Technical Service Bulletin: tsb100727

New Cam Cover Seals

This Technical Service Bulletin introduces new injector and valve cam cover seals for Signature™, ISX, and QSX15 series engines. Each new seal will obsolete and supersede the earlier version.

Figure 1, New Cam Cover Seal

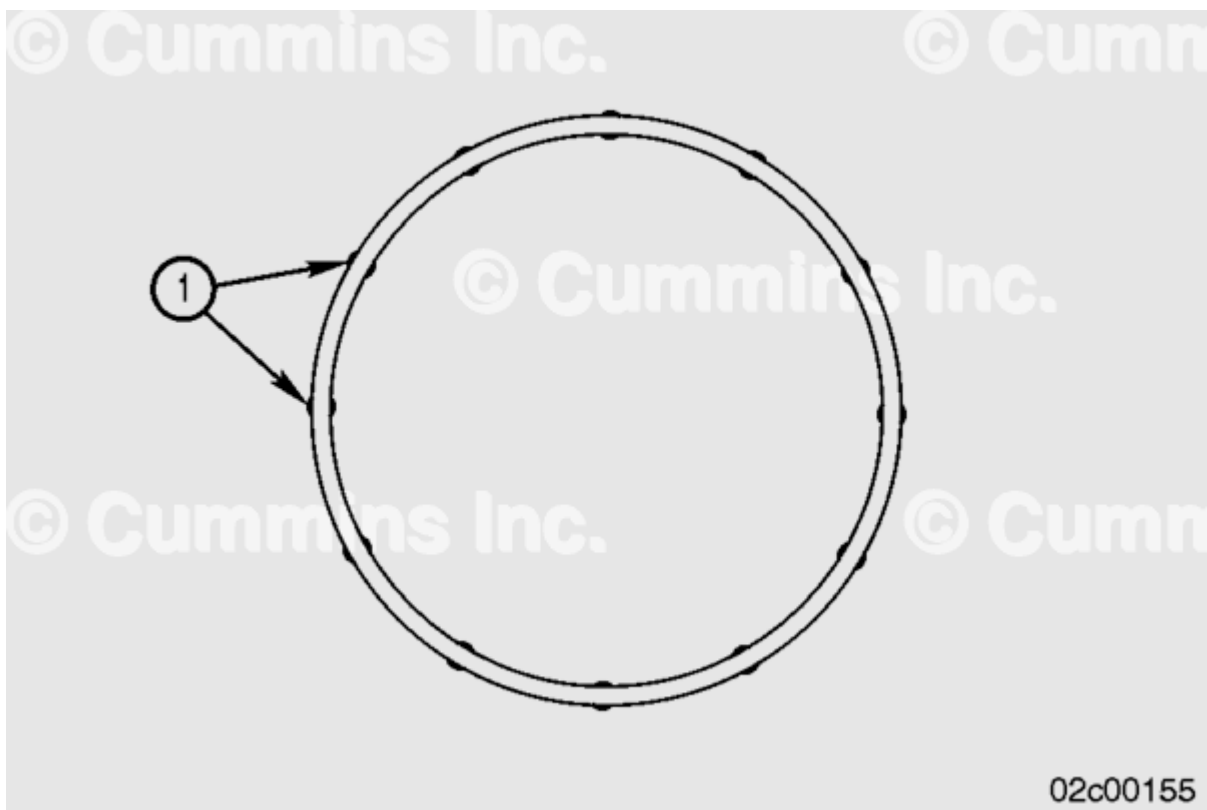
The new seals have been designed to make the assembly process easier and prevent leaks caused by mis-assembly. They are a press-in-place design, which are meant to be pressed into the seal retaining groove cut into the cam cover and stay in place without the need of an adhesive.

The new seals have retaining nubs (1), around both the inside and outside circumferences, that are designed to hold them in place. Because of this feature, they have a different appearance than the previous seals. The new seal is shown in Figure 1.
